# HISTORIC AND DESIGN REVIEW COMMISSION

June 15, 2022

**HDRC CASE NO:** 2022-085  
**COMMON NAME:** Young Women's Leadership Academy  
**ADDRESS:** 2123 W HUISACHE AVE  
**LEGAL DESCRIPTION:** NCB 6827 BLK LOT 41 SAISD MANN MIDDLE SCHOOL SUB  
**ZONING:** R-6, H  
**CITY COUNCIL DIST.:** 7  
**DISTRICT:** Monticello Park Historic District  
**APPLICANT:** Mitchell Ford/Cox McLain Environmental Consulting, Inc. - now Stantec  
**OWNER:** Nkonye Adaikpoh/SAN ANTONIO ISD  
**TYPE OF WORK:** Partial demolition, new construction of additions, window replacement, exterior alterations, site work  
**APPLICATION RECEIVED:** May 27, 2022  
**60-DAY REVIEW:** Not applicable Due to City Council Emergency Orders  
**CASE MANAGER:** Rachel Rettaliata  
**REQUEST:**

1. Demolish portions of the Young Women's Leadership Academy (historically known as Horace Mann Junior High school), construct new additions, and perform exterior alterations, repairs, and site improvements.
2. Replace nine (9) windows with salvaged fully wood windows to match.
3. Replace ten (10) doors.

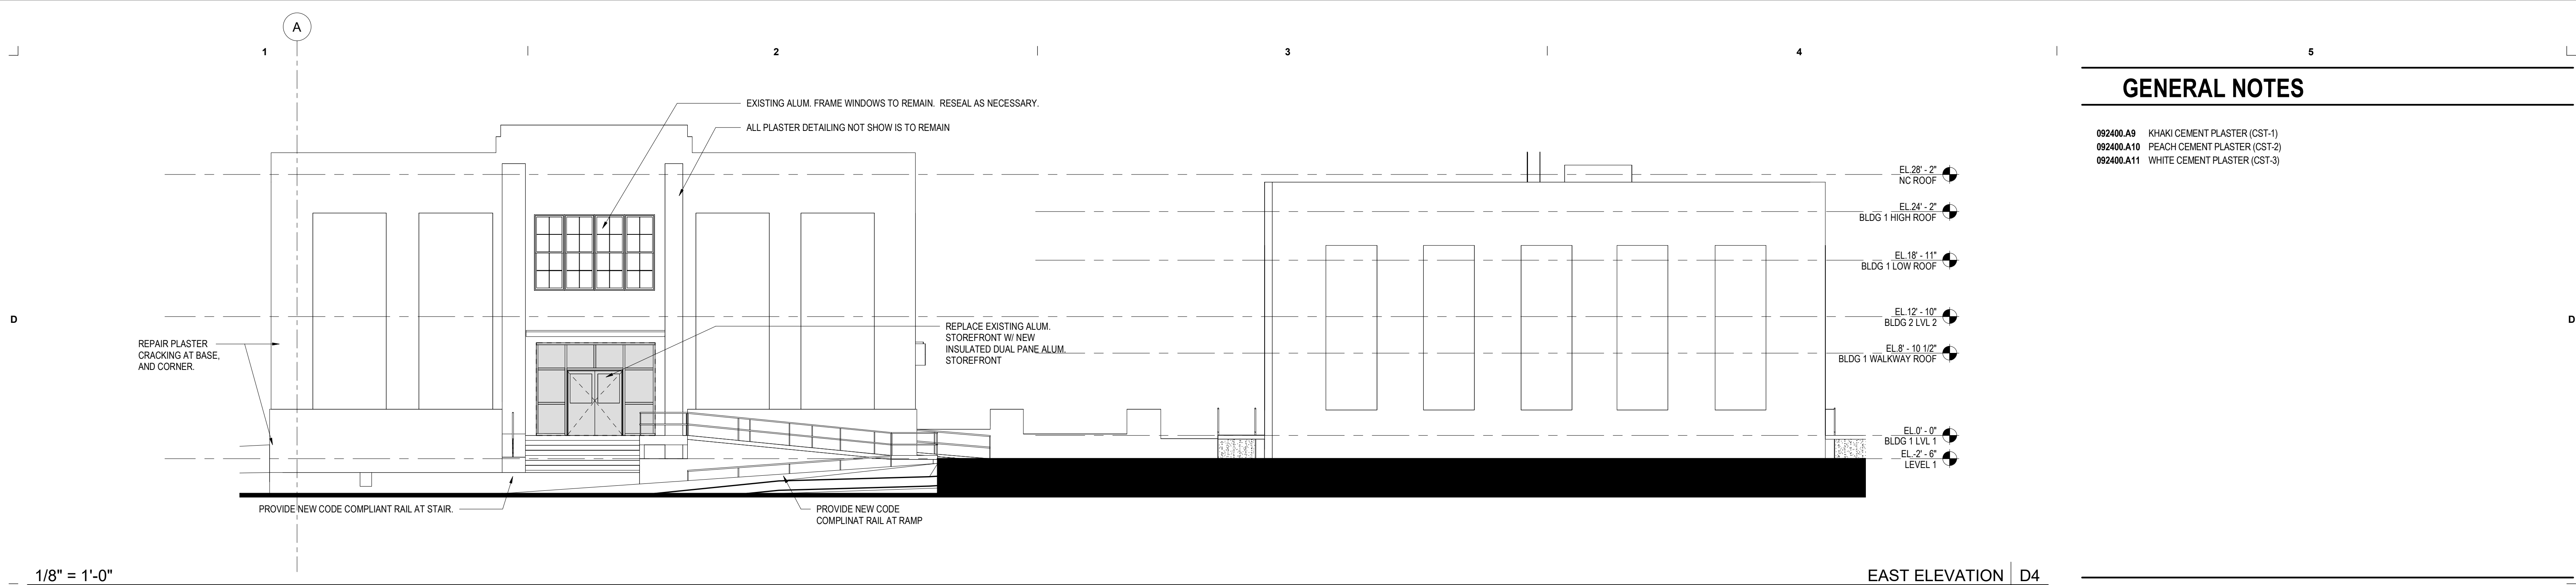
Jeffrey Fetzner: Thank you for the in-depth structural report. I can see a compelling argument for the removal of the library. I agree with Monica that you should look at the plans to make sure that the facades of the new construction aren't proud of the historic façade of the building.

Jimmy Cervantes: Is there a reason that the existing gymnasium is not currently working for you? The one that was built in the 50's.

Lisa Garza: A quick observation – noticing that a thorough job in replicating the vertical bays, the horizontal lines are missing a base. The new section has no base.

NS: We want to make sure that we have a school that is still functioning while the property is under construction. We want to make sure that everyone has equal access to learning spaces.

DETAIL A. NORTH ELEVATION COURTYARD VIEW  
ALTERED WINDOWS WITH VENTS; REPLACE WINDOWS WITH SALVAGED SASHES

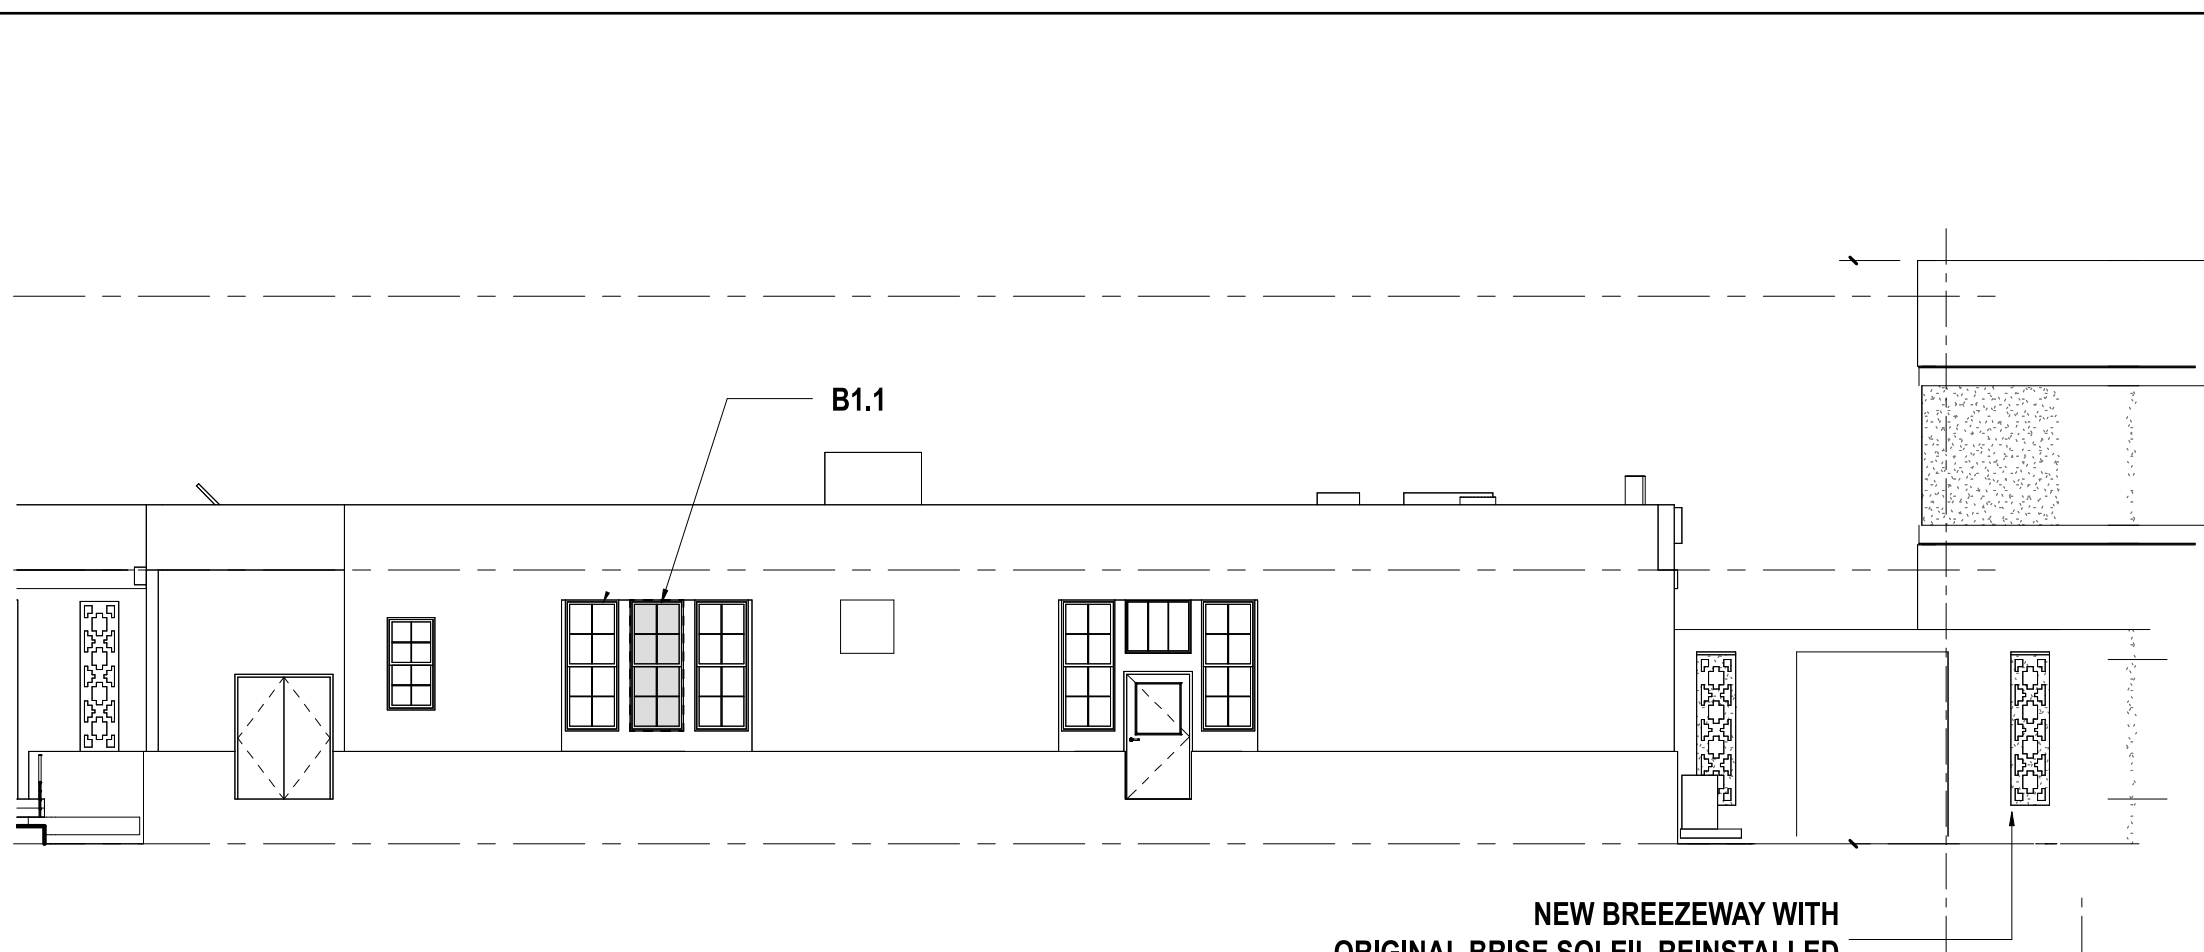
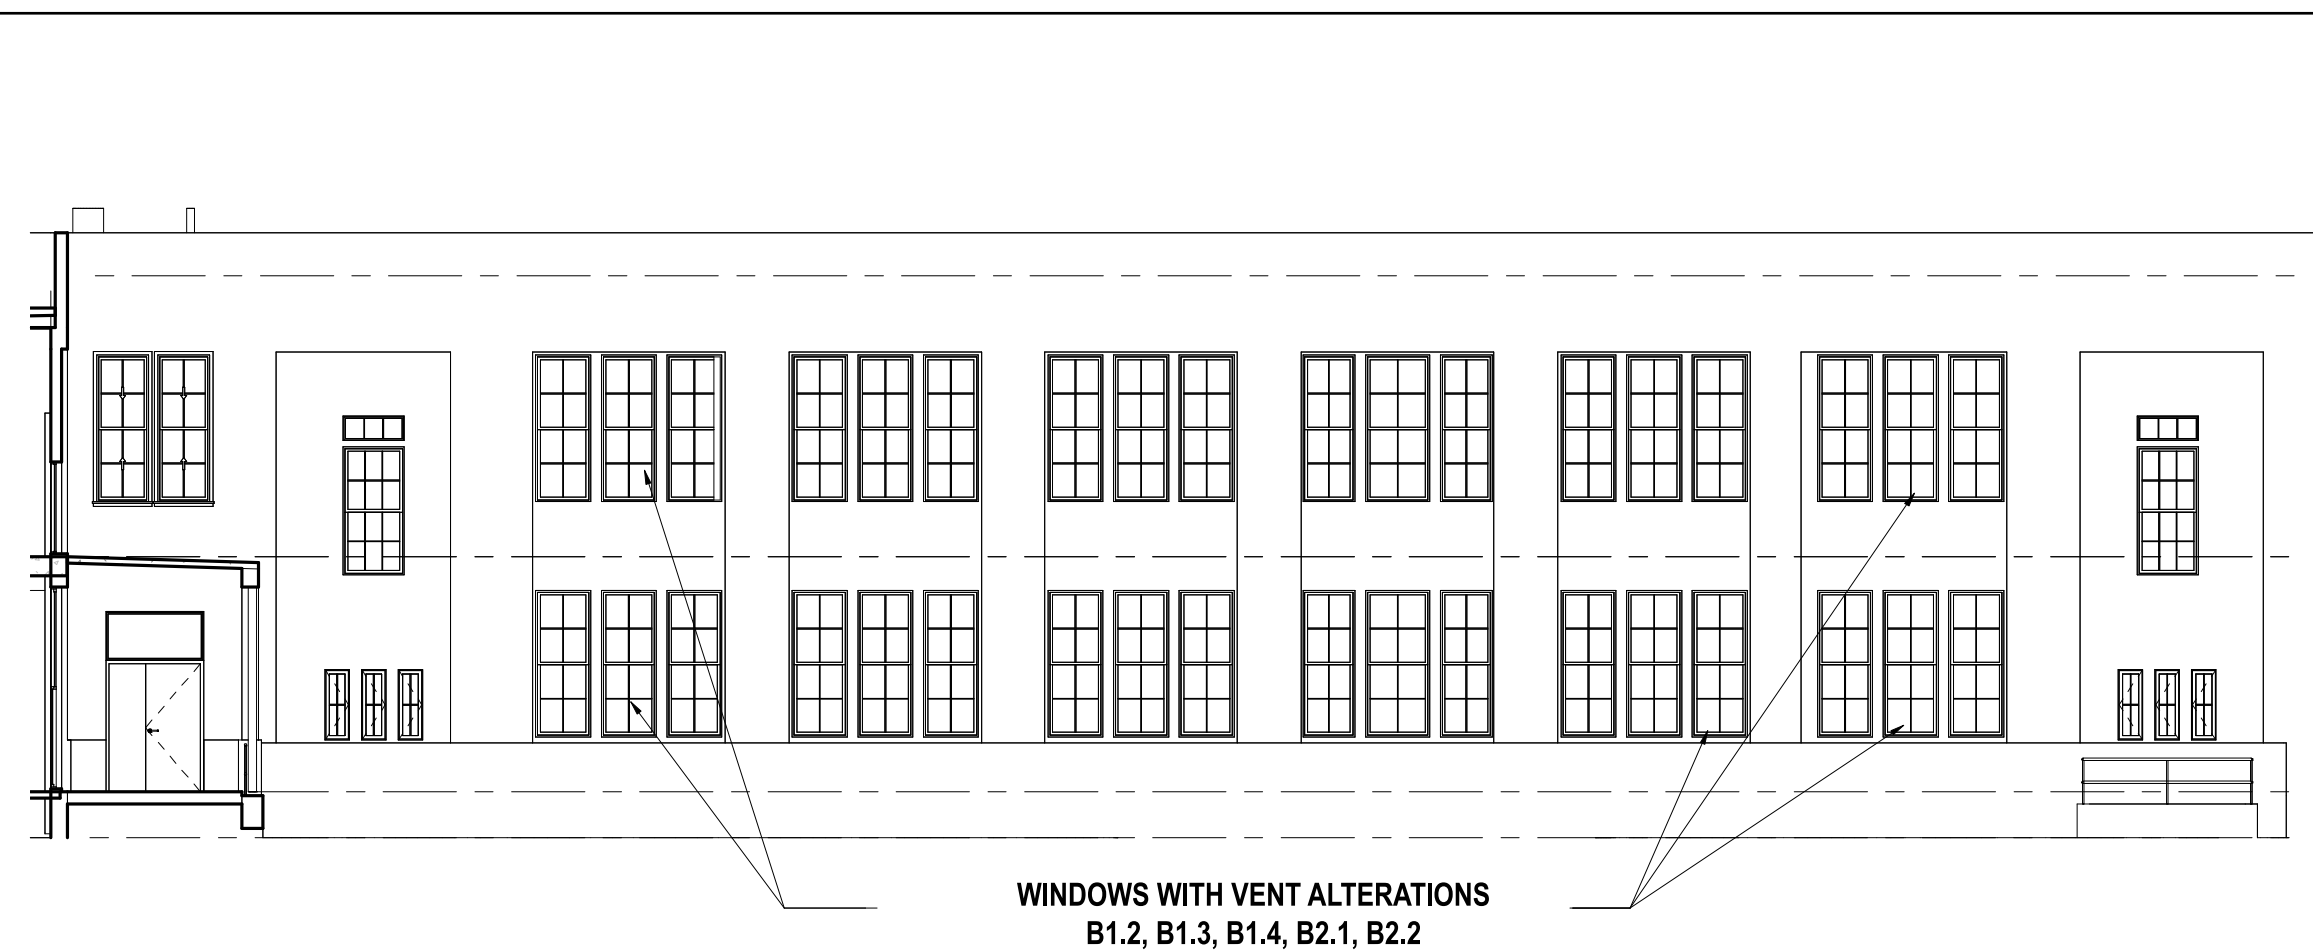
DETAIL B. NORTH ELEVATION REAR  
ALTERED WINDOWS WITH VENTS; REPLACE WINDOWS WITH SALVAGED SASHES

DETAIL C. SOUTH FACADE  
ALTERED WINDOWS WITH VENTS; REPLACE WINDOWS WITH SALVAGED SASHES

- y. **WINDOW REPLACEMENT** – The applicant has proposed to replace nine (9) windows that have been previously modified to feature mechanical units. The applicant has proposed to replace windows identified as A1.13, B1.1, B1.2, B1.3, B1.4, B1.6, B1.7, B2.1, and B2.2. The applicant has proposed to replace the modified windows with matching windows salvaged from the library, should demolition of the existing library structure be approved. The applicant has proposed to repair the remaining wood windows. Guideline 6.B.iv for Exterior Maintenance and Alterations states that new windows should be installed to match the historic or existing windows in terms of size, type, configuration, material, form, appearance, and detail when original windows are deteriorated beyond repair. According to the Historic Design Guidelines, wood windows should be repaired in place and restored whenever possible, unless there is substantial evidence that the windows are deteriorated beyond repair. If a window assembly is deemed irreparable, the window should be replaced in-kind in terms of materiality, configuration, inset, proportion, style, and detailing. As noted in finding v, staff finds that all original wood windows are in repairable condition; however, staff finds the proposal to replace nine (9) modified windows with salvaged wood window sashes to match existing to be appropriate for only the sashes that have been compromised due to the installation of mechanical units. Staff does not find the unmodified windows in each ganged set to be eligible for replacement.
